Barangaroo - Concept Plan Modification
(Headland Park and Northern Cove)
Preferred Project Traffic Report

FINAL

1 September 2009

Prepared for
Barangaroo Delivery Authority

POTENTIAL ALTERNATIVE HEADLAND CAR PARK ACCESS

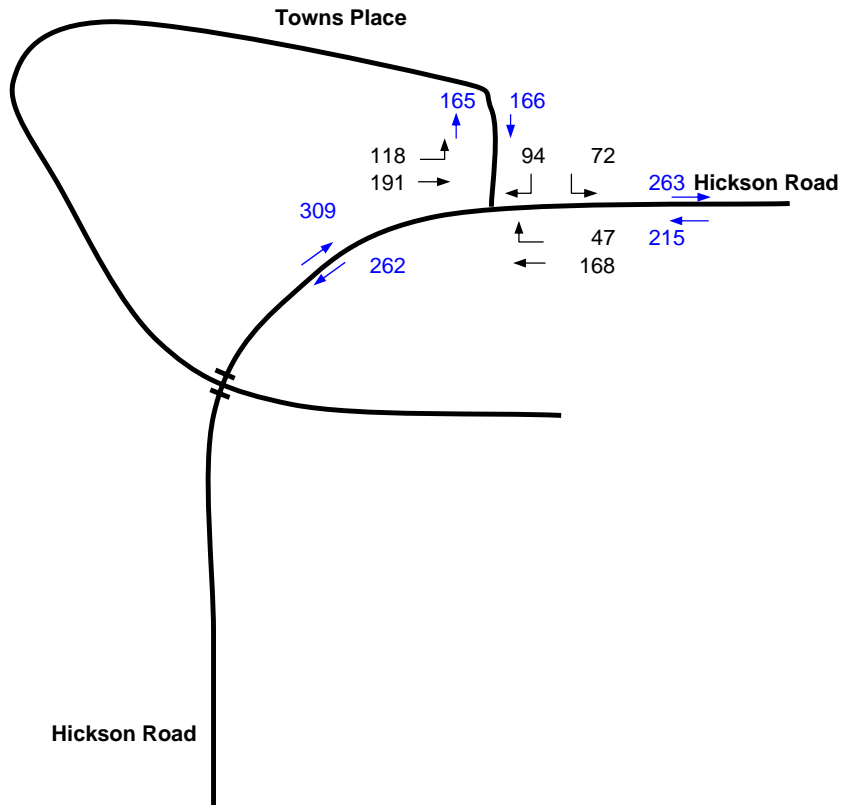
A number of public submissions received in relation to the Barangaroo Part 3A Modification – Headland Park and Northern Cove comment in relation to the impact of traffic associated with the Headland car park on Towns Place/Dalgety Road and its surrounding streets.

The original traffic assessment for the Barangaroo Concept Plan envisaged that the Headland car park access would be provided from Hickson Road. At that time it was proposed that such access would occur through a more consolidated Barangaroo site. The introduction of the Northern Cove means that the car park access could not be provided in this way.

The present concept provides for vehicular access to be provided at the point of connection of Towns Place to Dalgety Road. If provided at this location, it would be logical for safety and traffic efficiency reasons to provide a roundabout at the junction point. An advantage of this access location is that it would afford convenient access from Hickson Road in each direction as well as from the upper levels at Millers Point.

The expected peak hourly traffic generation of the car park is only about 120 vehicle movements per hour and this volume of traffic would easily be handled by the roads feeding to and from the access point.

It would be possible to provide access to the proposed car park directly off Hickson Road via the existing driveway at Gate D4. This is illustrated on **Figure 1** of this report. This access would require a driveway of about 150m in length compared to one of about 125m in length to Towns Place. The advantage of this alternative location is that it would reduce resident concerns about additional traffic in Towns Place/Dalgety Road and would afford an access address that better connected the car park to the wider Barangaroo Project.
